Contract No. T201820003.01
Federal Aid Project No. ESTP-2018(22)
Slaughter Beach Scenic Overlook
Sussex County

Enclosed is Addendum No. 1 for the referenced contract consisting of the following:

Slaughter Beach Scenic Overlook

TYPICAL SECTION: Beams at Timber
Piles
SCALE: 1/2" = 1'-0"

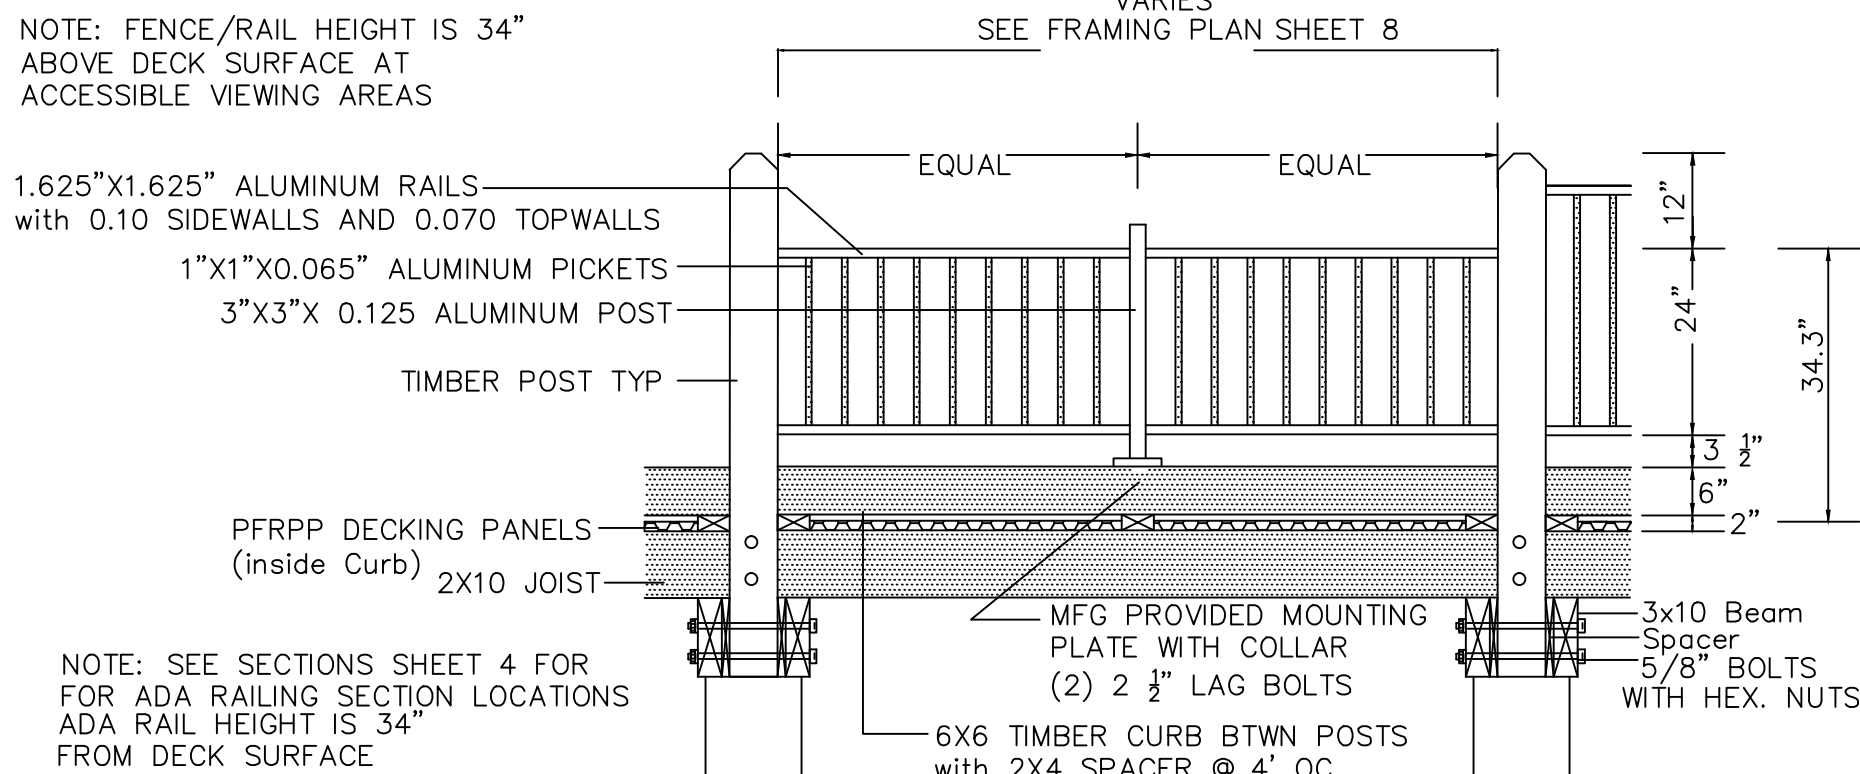
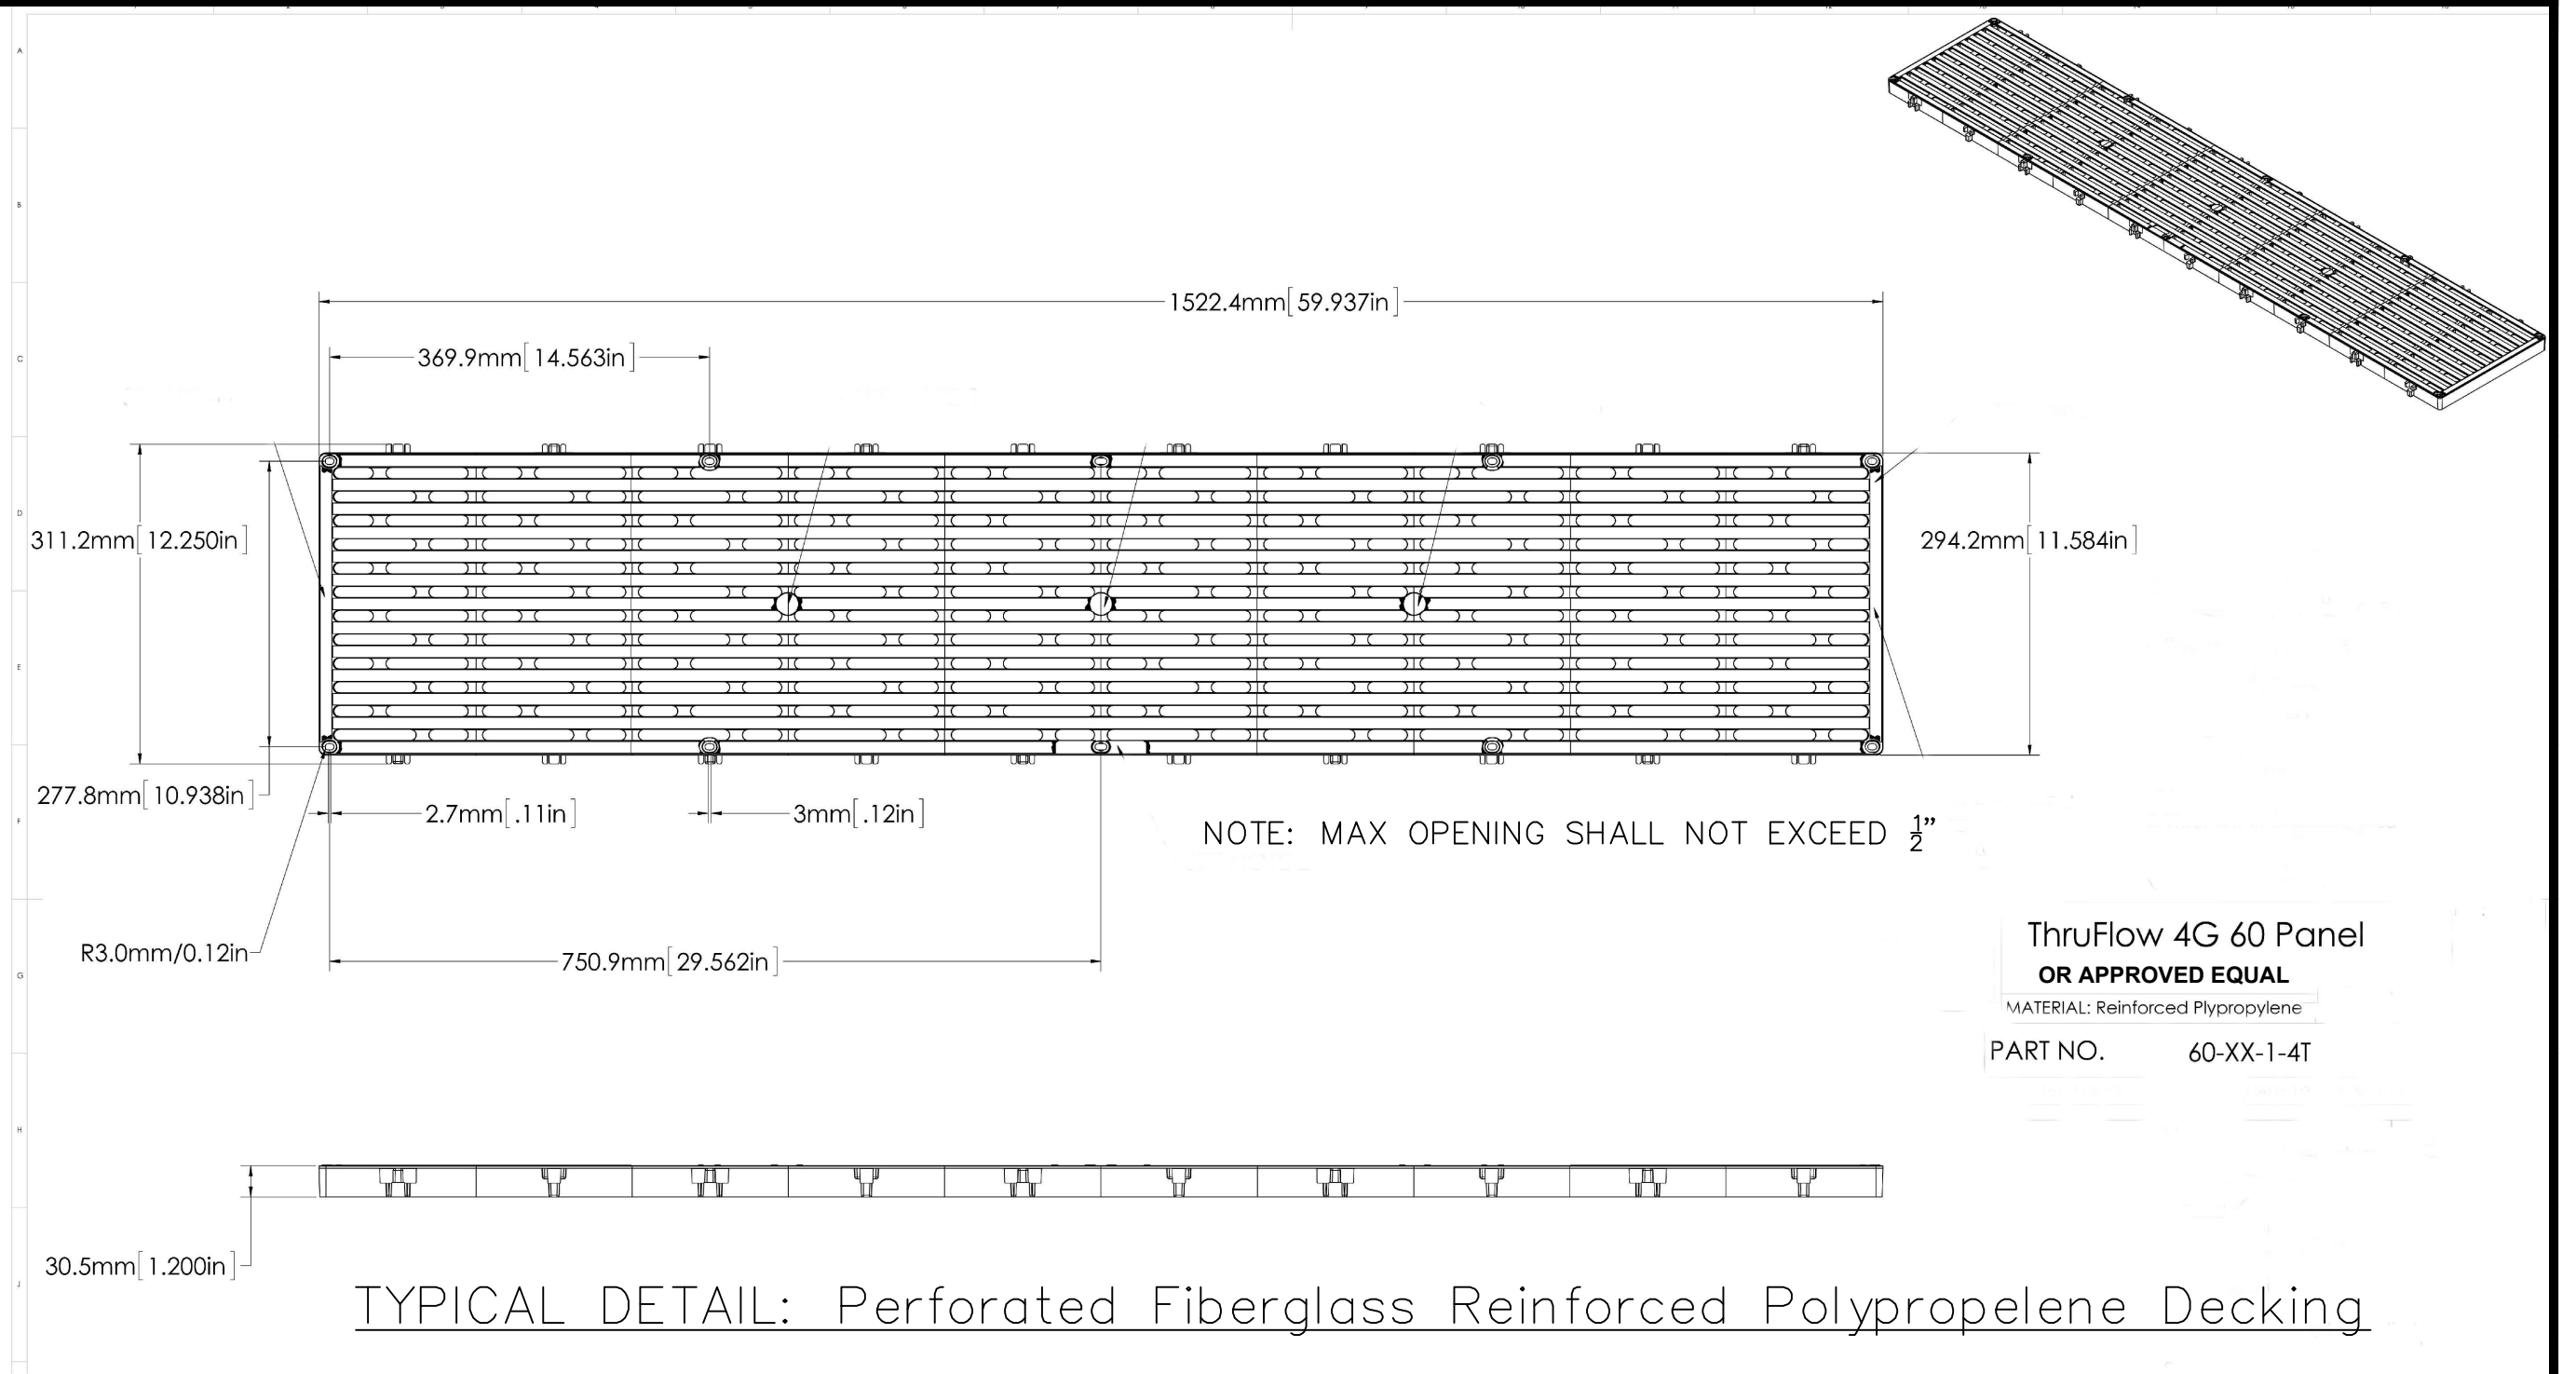
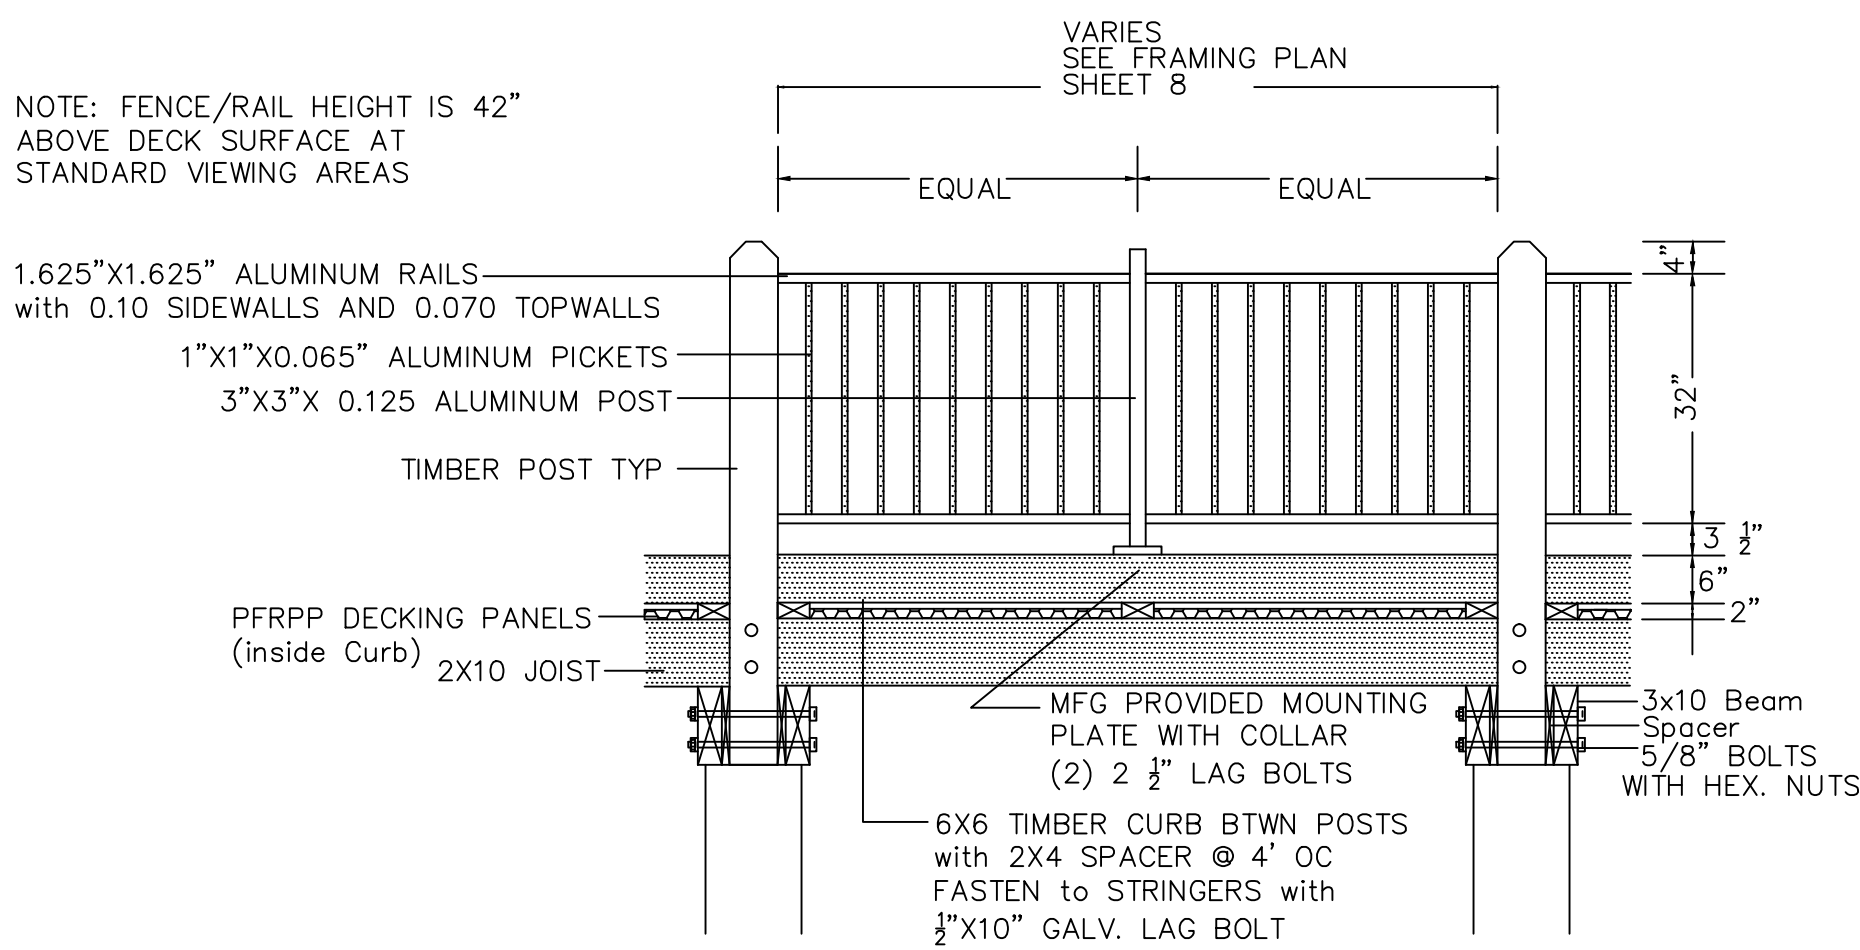
ADDENDA / REVISIONS			
Δ	REVISED TIMBER PILE EMBEDMENT DEPTH TO 28'-0" BELOW EXISTING GROUND	10/3/18	MS
